Rezoning Transportation Analysis

Petition Number: 2020-046

General Location Identifier: Tax ID 20103128

Date	Description
04-21-20	First Review
05-20-20	Second Review (FO)

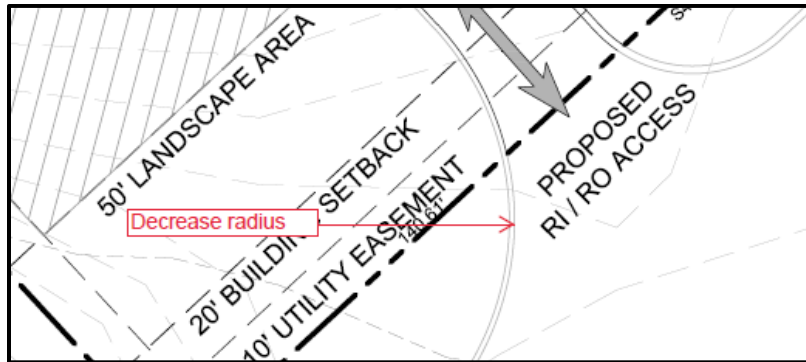
- ~~4. In reference to the Urban Street Design Guidelines (USDG), CDOT recommends the petitioner to revise the site plan and conditional note(s) to decrease the Tryon right out only radius for a SU-30 vehicle only, using Condition D of Appendix C of the USDG.~~
